From: Matthew Gunning <Matthew.Gunning@haringey.gov.uk>
Sent: 03 September 2026 17:18
To: Natasha Dawson <natasha@quadrantdesign.co.uk>; Benjamin Coffie <Benjamin.Coffie@haringey.gov.uk>
Cc: Emma Roshier <emma@quadrantdesign.co.uk>; Matt Sears <matt@quadrantdesign.co.uk>; Stuart Kern <stuart@quadrantdesign.co.uk>
Subject: RE: further details - HGY/2026/1790

HGY/2026/1790 - Restaurant, 2 Highgate High Street, Hornsey, London, N6 5JL

Having reviewed the submitted drawings and application I am writing to outline that there are concern relating to the signage at the above addresses. Specifically, there is a lack of clarity regarding the proposed external finishes and the visual impact of the proposed yellow colour within this prominent conservation area setting.

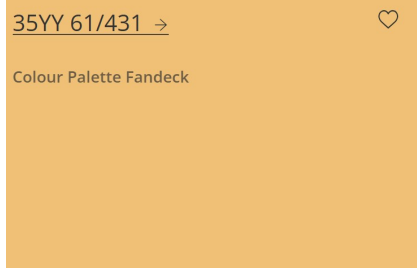
I note the details provided in relation to the proposed colour palette, which appears to be a more muted ochre tone rather than a bright yellow. However, to ensure that I have an accurate understanding of the proposed finishes, could you please review the below/ send colour samples/images for each of the specified colours and materials.

Docril Tweed
Yellow 00075

Projecting sign
panel-
“RAL0758050”

Dulux, prairie
grass, 35yy
61/431

This will help ensure there is complete clarity regarding the proposed colour scheme before determination.

Yes, you are absolutely correct. The colours below are the muted yellow tones we have chosen for the various components of the shopfront.
